PZBA12-00001 1100 Saint Johns Drive Gerardo Espinoza
Applicant requests a Special Exception under Section 2.16.050 J (Carport over a Driveway) in an R-4 (Residential) zone.

MEMORANDUM

SUBJECT: CARPORT CASE FOR February 13, 2012 ZBA MEETING

SHEET No. S1

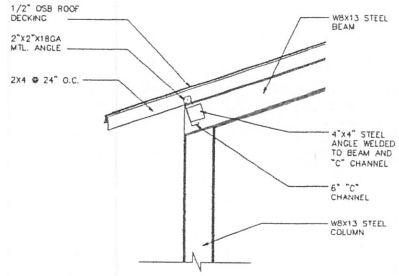
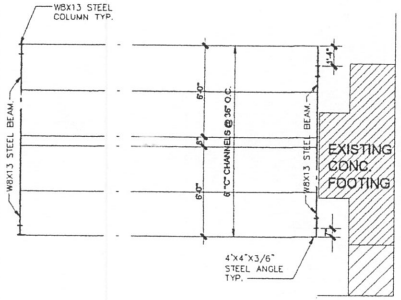
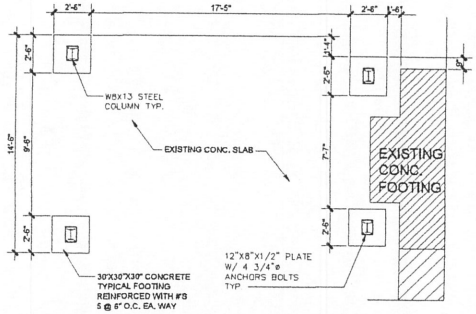
The carport's structural design has been reviewed and has been found to be not acceptable:
Need engineer's seal for metal structure.
